CITY OF PORT PHILLIP DELEGATE REPORT

APPLICATION NO:	PDPL/00817/2022
ADDRESS:	146, 148 & 150 Bridport Street, Albert Park
APPLICANT:	Squareback Pty Ltd
PROPOSAL:	Planning Permit for partial demolition and construction of a six storey building above basement car parking within the Heritage Overlay (HO443); the use of the land for dwellings and a reduction in the number of car parking spaces required under Clause 52.06-5 for the Restaurant (as of right).
ZONE:	Commercial 1 Zone
OVERLAYS:	Heritage Overlay (HO443)
CULTURALLY SENSITIVE SITE:	No
GRADING OF BUILDING:	Significant
WARD:	Lake Ward
ADVERTISED?:	Yes 219 objections
PRE-APPLICATION MEETING HELD?:	No
DATE OF ON-SITE INSPECTION: (Photos retained on file)	N/A
SDA/SMP SUBMITTED?:	N/A
DELEGATION:	No delegation needed for refusal
<input type="checkbox"/> Reduction in residential parking. <input type="checkbox"/> Non-compliance with 10° sightline policy. <input type="checkbox"/> Demolition of signif/contrib building.

Figure 12 - Proposed ground-floor plan showing setbacks of windows at the Biltmore site (immediately west of site)

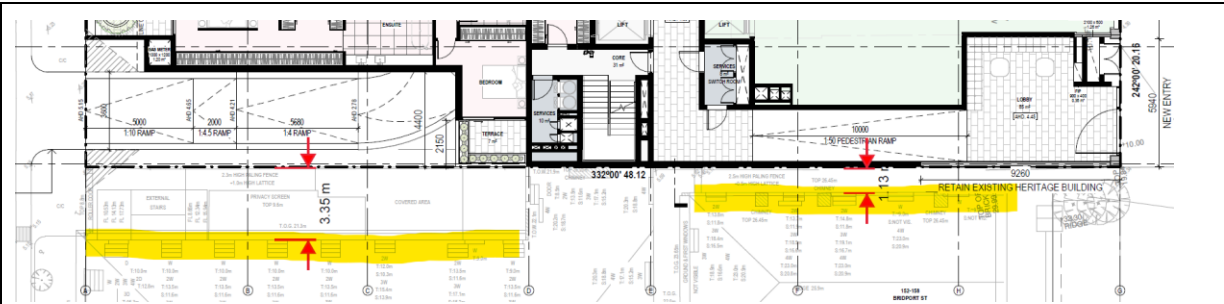
Refer Figure 12 which shows these windows in plan form.

Above ground level, the proposal would provide a 3m setback to the boundary which when combined with the generally just over 3m adjacent setback would provide an overall separation of just over 6m.

It is considered that this arrangement would also represent sufficient separation to maintain reasonable good daylight access to both existing and proposed developments. It is, however, noted that the proposal would be approximately 16m taller than the first floor level of the abutting Biltmore building where separated by the abovementioned just over 6m. If the daylight tests of Rescode are used as a form of guide, an 8m separation should be achieved. This would be a guide only. Even so, in this context, it is considered that

Figure 13 - Western elevation showing existing context set opposite the windows at the Biltmore - approximate location of neighbouring windows highlighted in red.

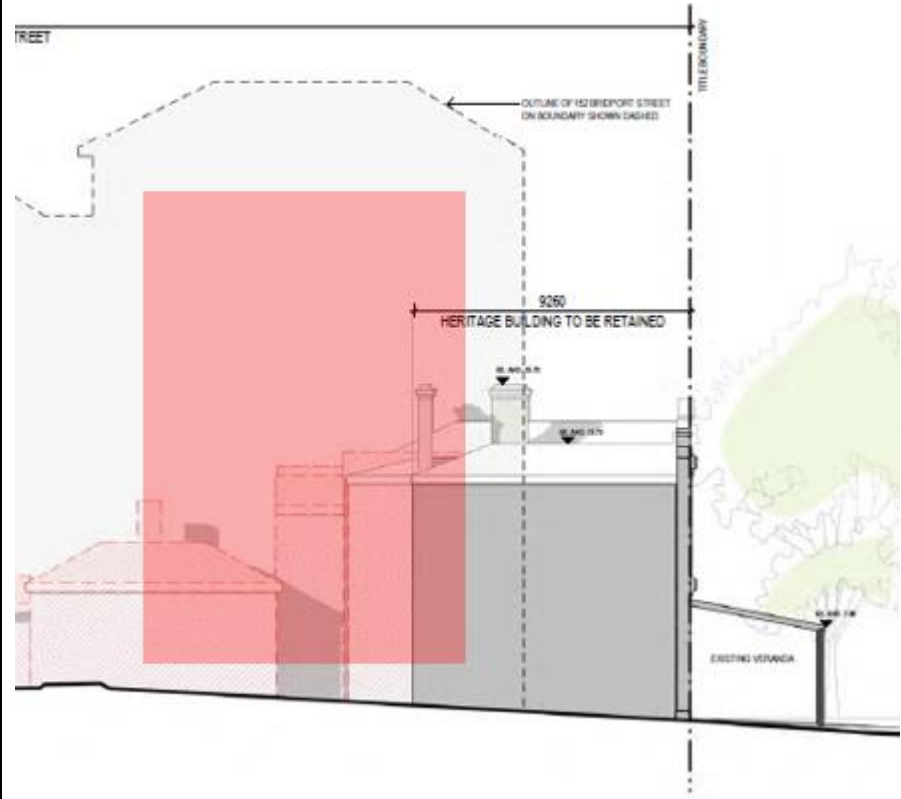
See Figure 13 which demonstrates this arrangement.

Figure 14 - Proposed built-form set opposite the windows at the Biltmore (approximate location highlighted in red)

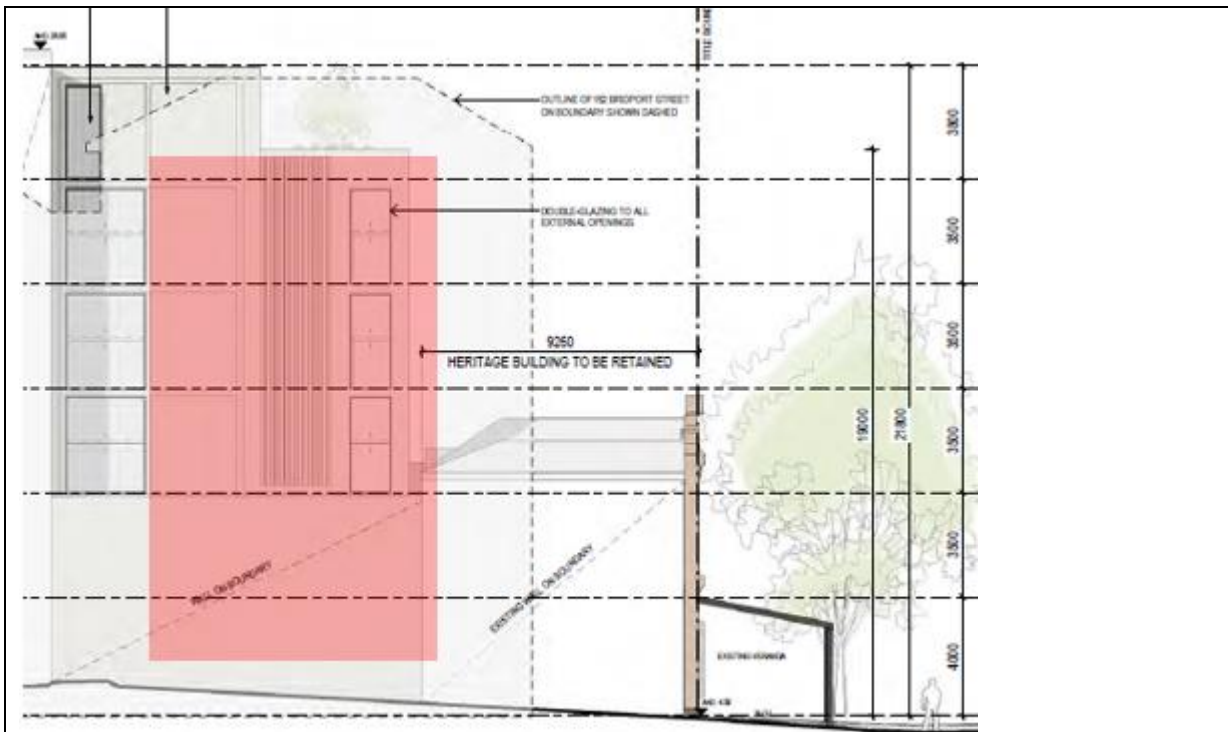
See Figure 14 which demonstrates this proposed arrangement.

Figure 17 - Parking permit zone configuration showing large areas of surrounding streets as timed public parking (green)

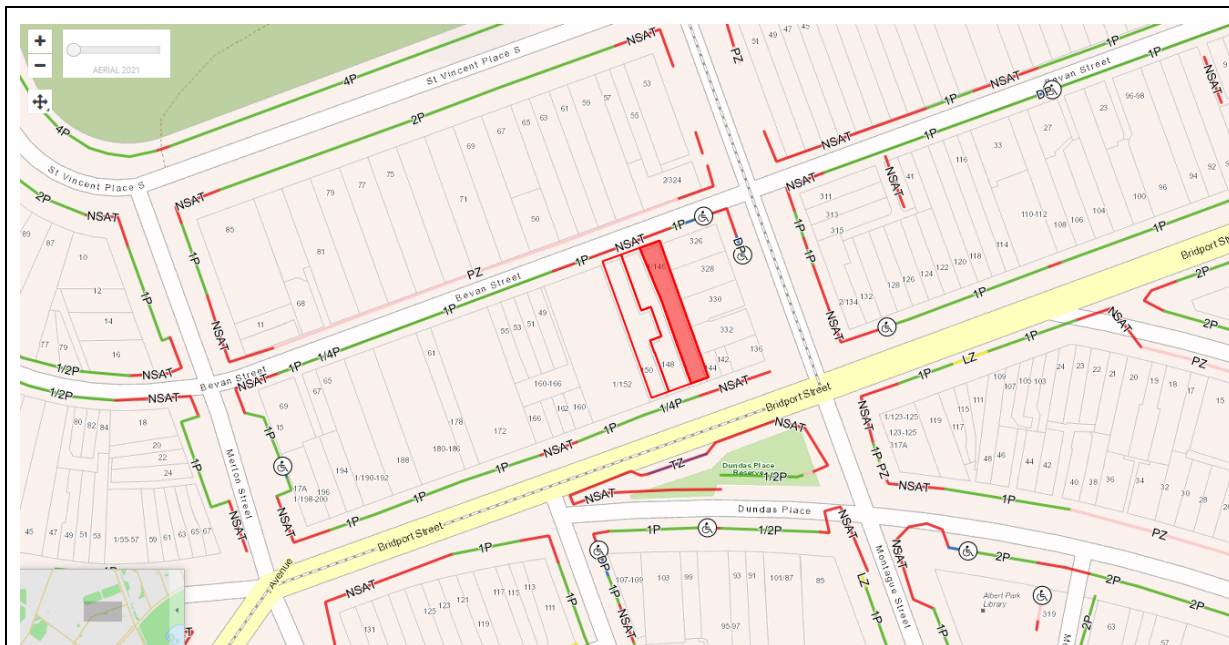
<p>The availability of alternative car parking in the locality of the land, including:</p> <ul style="list-style-type: none"> - Efficiencies gained from the consolidation of shared car parking spaces. - Public car parks intended to serve the land. - On street parking in non residential zones. - Streets in residential zones specifically managed for non-residential parking. 	<p>The site is well served by a large number of public parking spaces both within Bridport Street and in surrounding streets. The vast majority of on-street parking spaces are time restricted with some allowing up to 4 hours stay.</p> <p>Residential on-street parking is generally reserved by way of Permit Zones in some surrounding streets.</p> <p>The volume of on-street parking in surrounding streets is considered to be sufficient to support an additional 22 spaces arising from the restaurant use. The reduction of spaces for the restaurant use can therefore be supported in this instance.</p>
